[Docket No. 2000-SW-60-AD]

Airworthiness Directives; Bell Helicopter Textron, Inc., Model 412 Helicopters

ACTION: Notice of proposed rulemaking (NPRM).

FIGURE 1

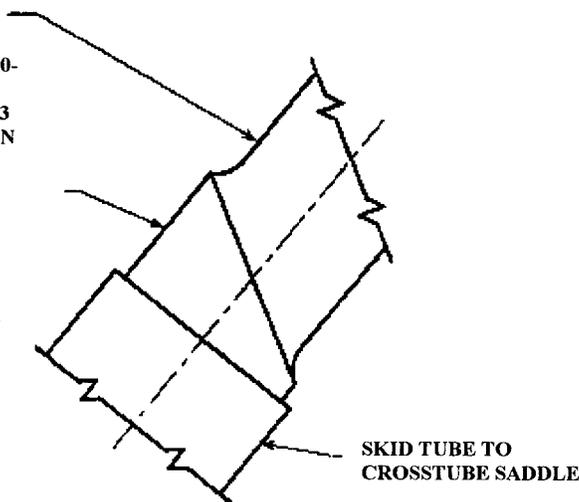
(3) Vibro-etch the P/N on the crosstube assembly adjacent to the skid tube saddle in accordance with Figure 1 for any crosstube assembly not displaying a visible P/N. Identify the crosstube assembly as P/N 412-050-011-107 FM.

(4) Vibro-etch a serial number (S/N) on the crosstube assembly below the P/N in accordance with Figure 1. The S/N must be unique for each crosstube assembly.

VIBRO-ETCH 412-050-011-107 FM AND A COMPANY CONTROLLED S/N IN THIS AREA AS REQUIRED TO TRACK REMAINING HIGH AFT CROSTUBE LIFE. VIBRO-ETCHING DEPTH SHALL NOT EXCEED 0.005 INCH.
